Addendum 2
TFM-044-25

PROJECT NAME:
MUN BRUNEAU CENTER FOR RESEARCH AND INNOVATION (IIC) HEATING UPGRADES

Addendum 1
TFM-044-25

DRAWING TITLE:
LEVEL 1 FLOOR PLAN - NEW HYDRONIC PIPING LAYOUT

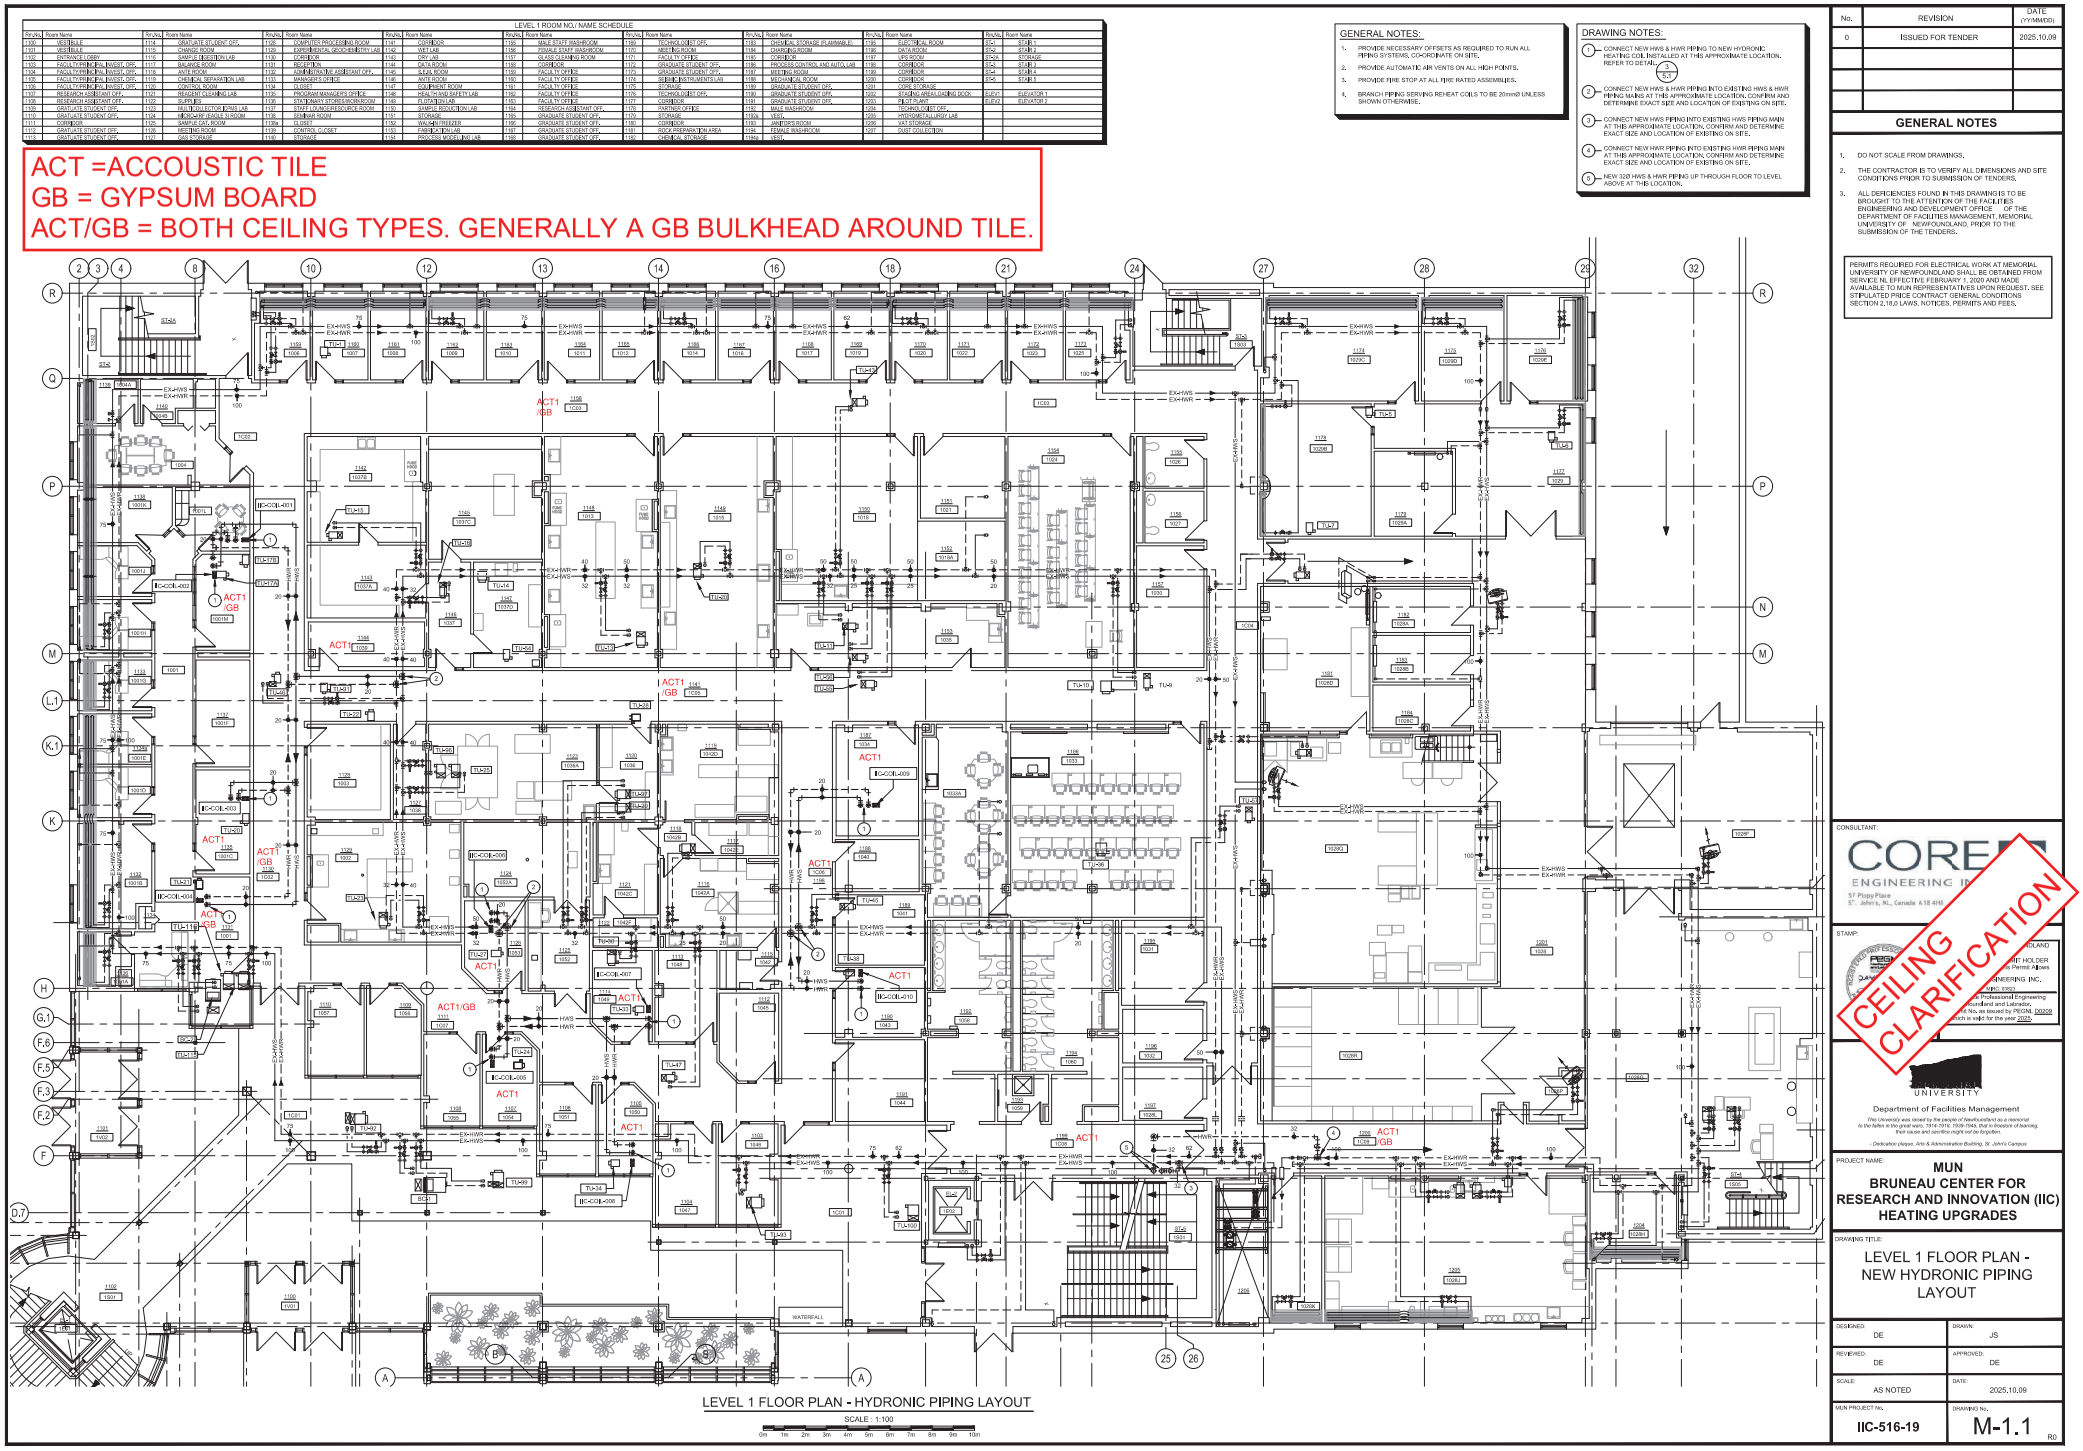
.1 Ceiling types are generally acoustic tile, some areas have gypsum bulkheads with portions of tile. Refer to attached drawing markup. <<3451 – Mun Bruneau Centre level 1 & 2 Ceiling types markup.pdf>>

CEILING CLARIFICATION

ACT =ACCOUSTIC TILE
GB = GYPSUM BOARD
ACT/GB = BOTH CEILING TYPES. GENERALLY A GB BULKHEAD AROUND TILE.

LEVEL 2 FLOOR PLAN - NEW HYDRONIC PIPING LAYOUT

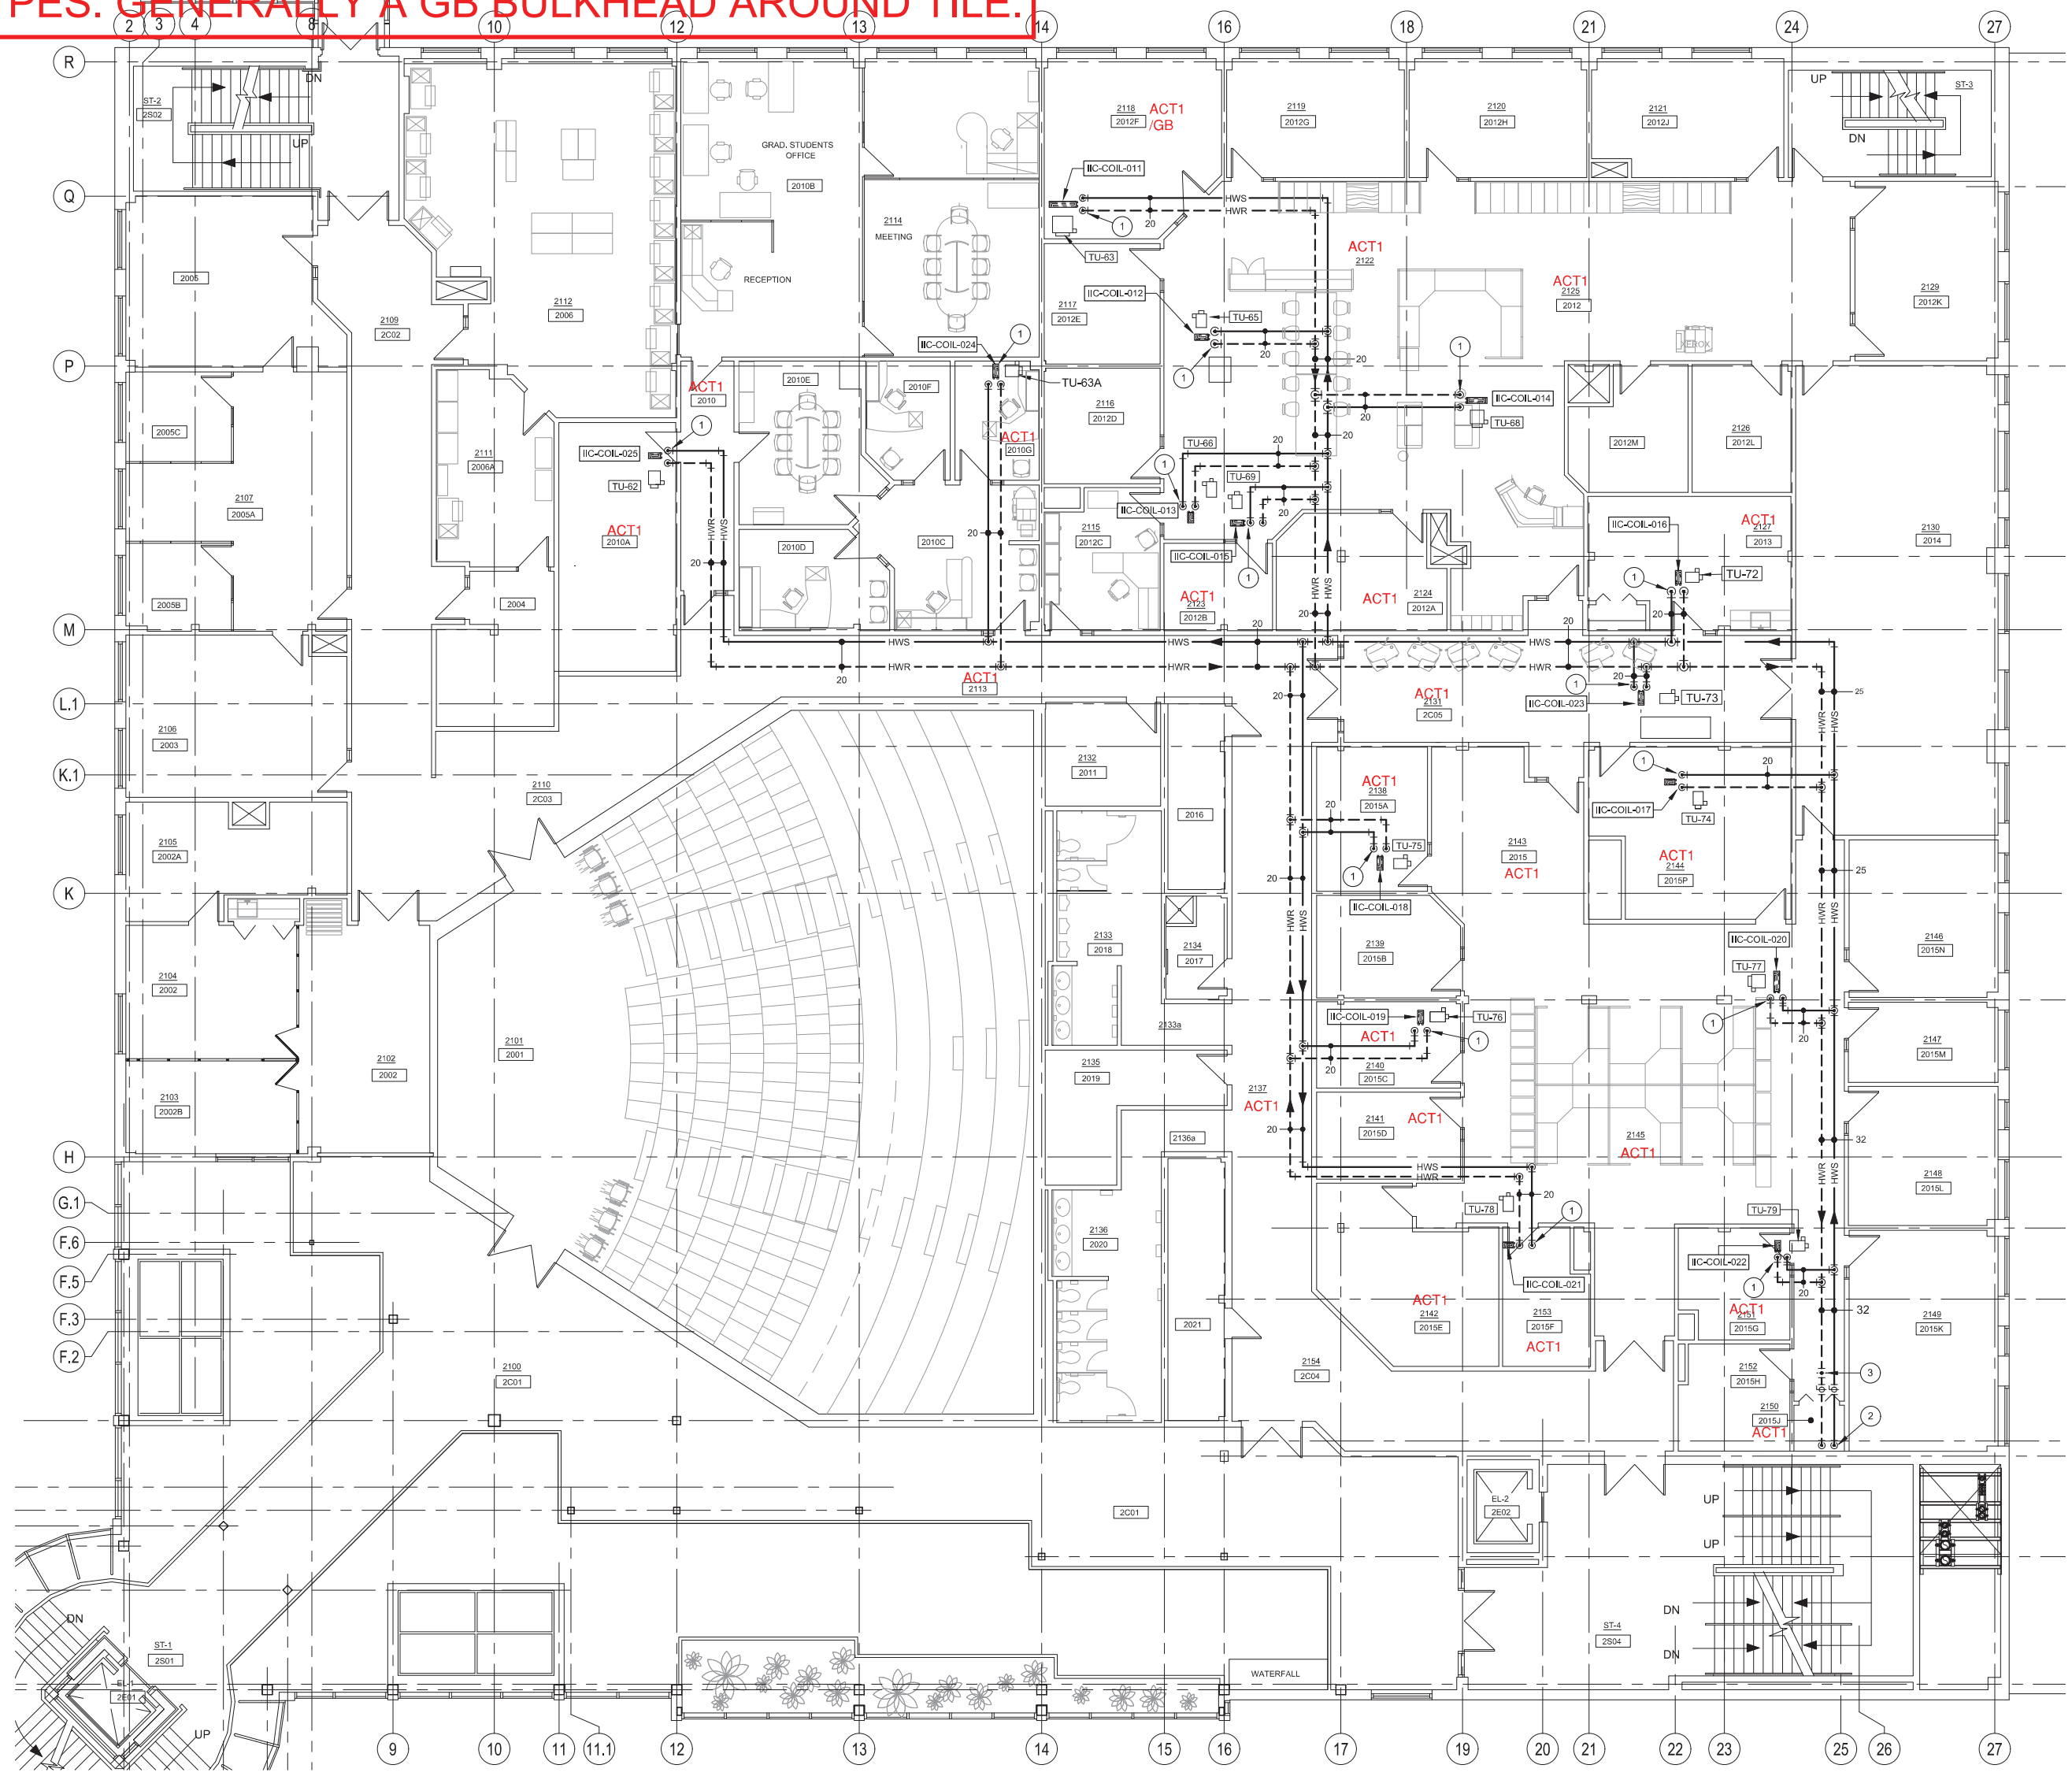
CEILING CLARIFICATION

ACT =ACCOUSTIC TILE
GB = GYPSUM BOARD
ACT/GB = BOTH CEILING TYPES. GENERALLY A GB BULKHEAD AROUND TILE.

DRAWING TITLE:
LEVEL 1 FLOOR PLAN - NEW VENTILATION LAYOUT

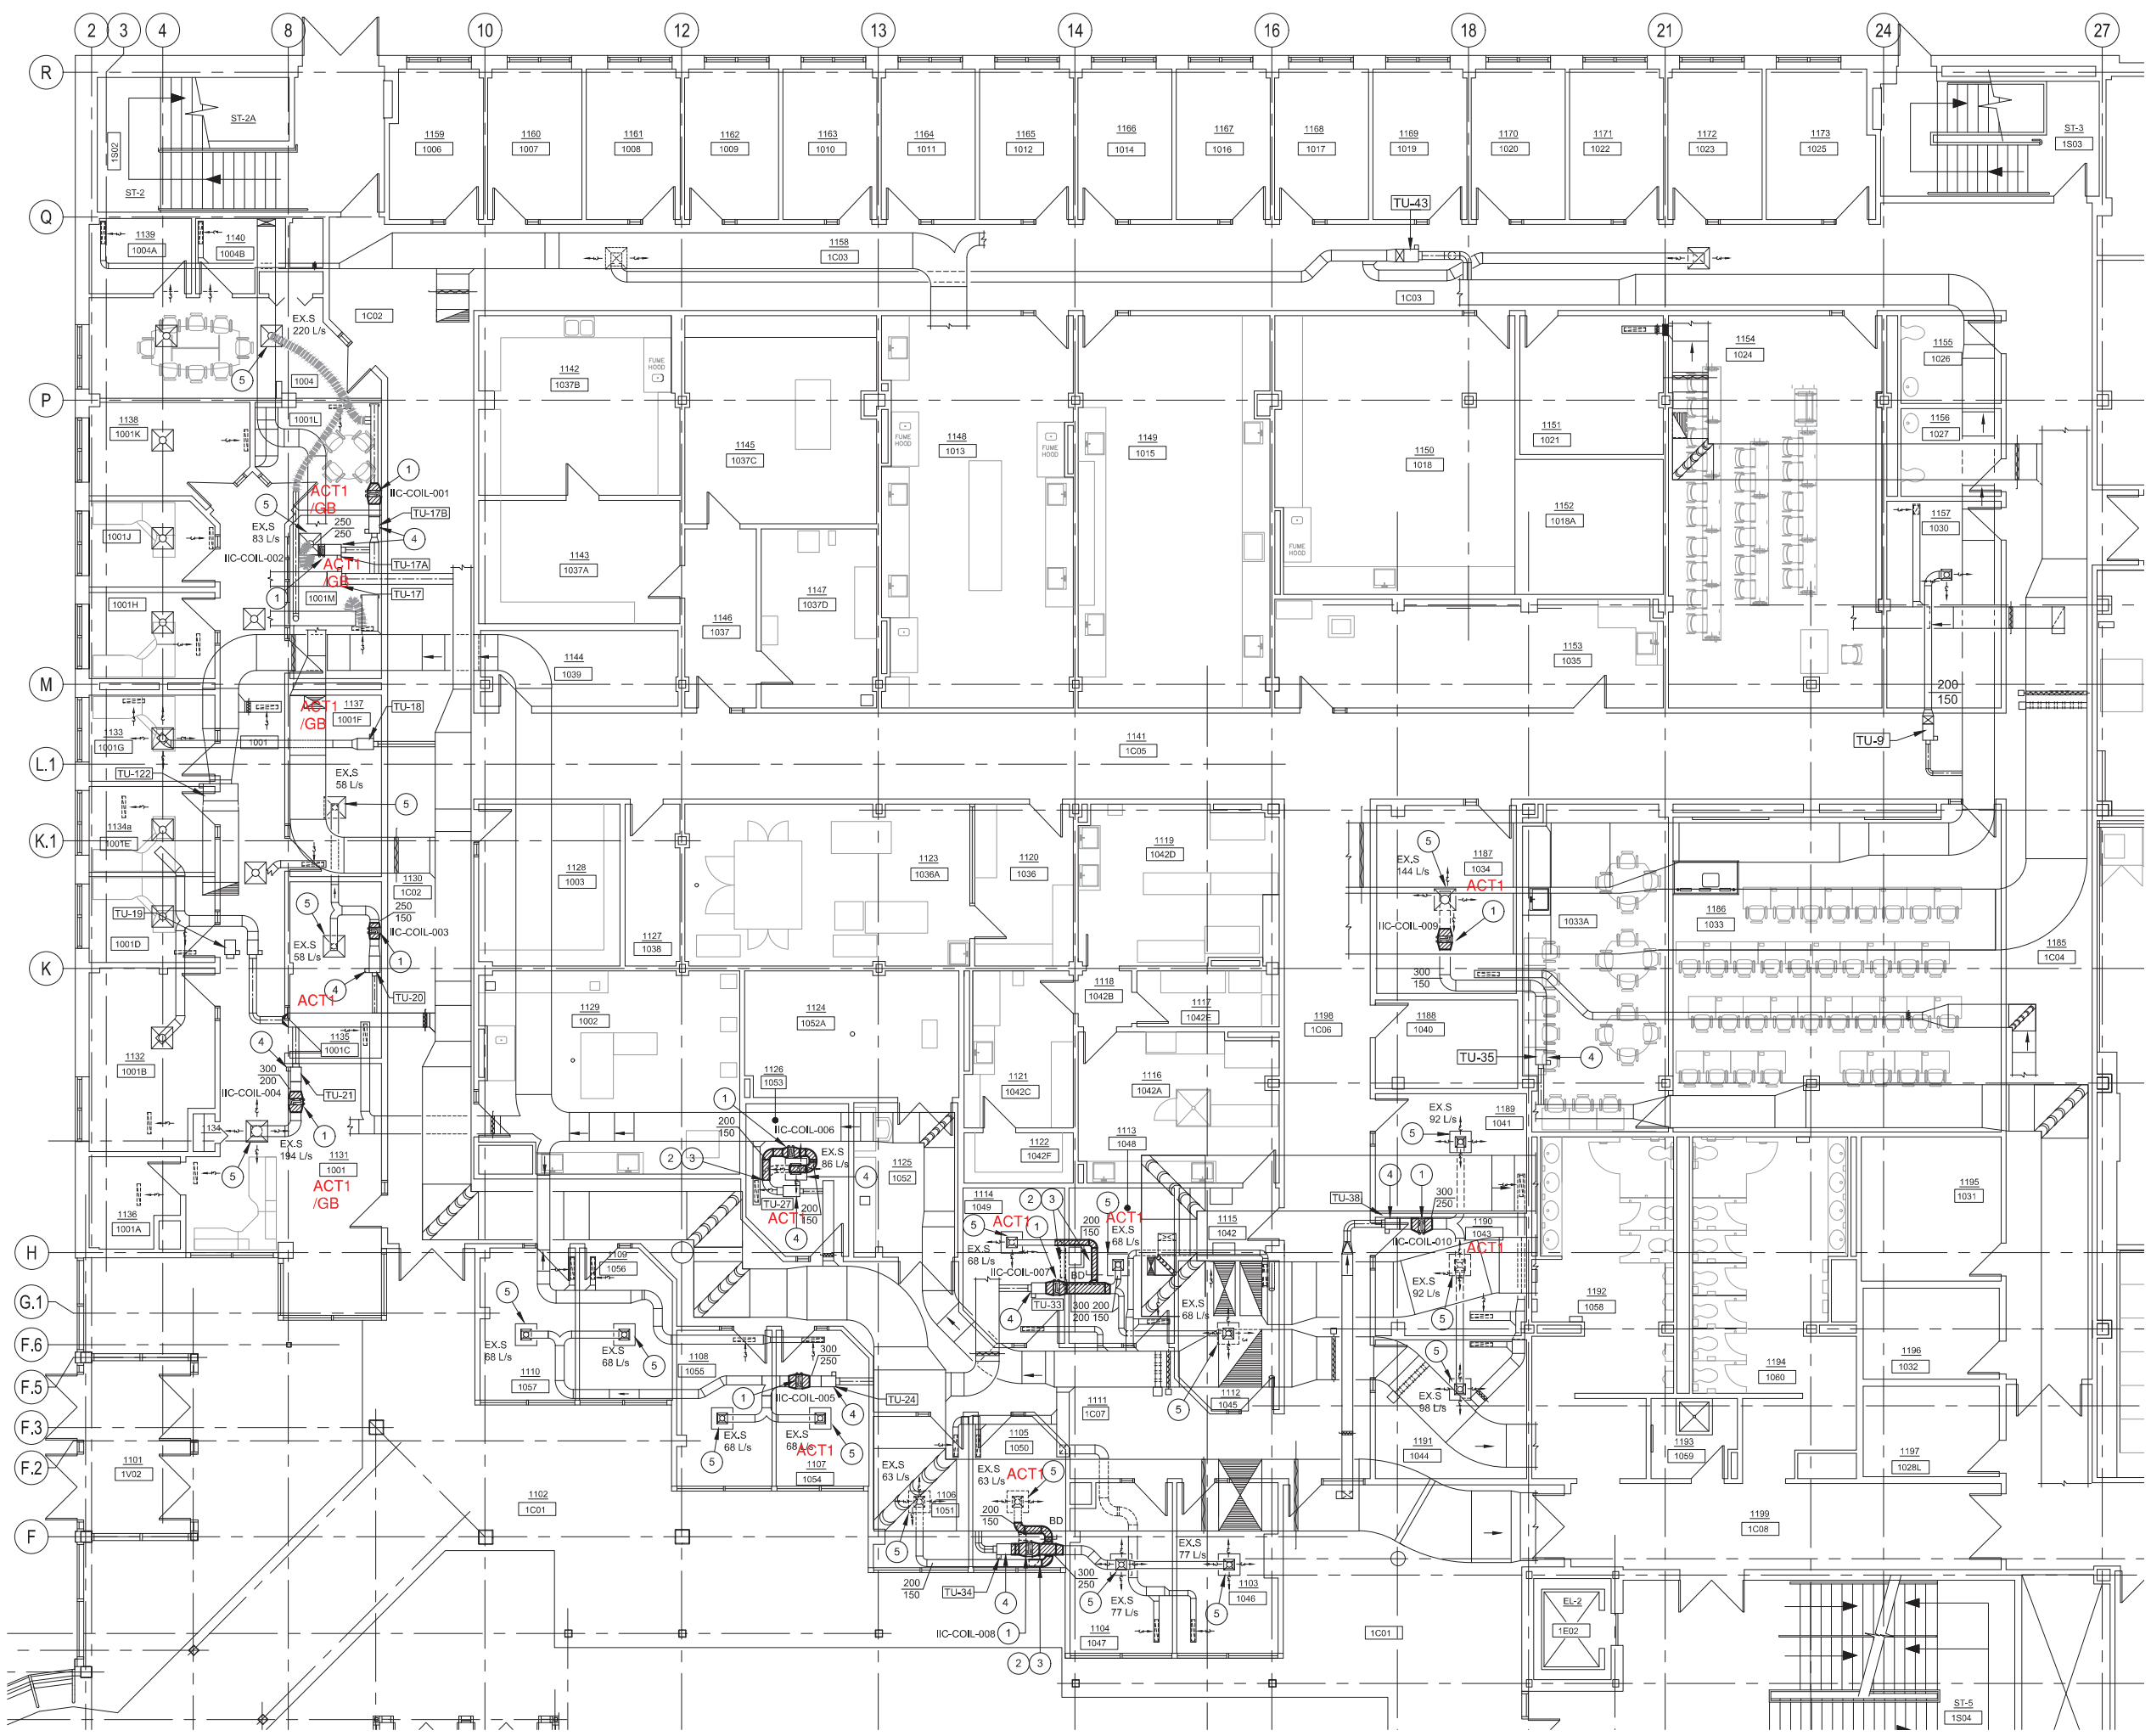
CEILING CLARIFICATION

ACT =ACCOUSTIC TILE
GB = GYPSUM BOARD
ACT/GB = BOTH CEILING TYPES. GENERALLY A GB BULKHEAD AROUND TILE.
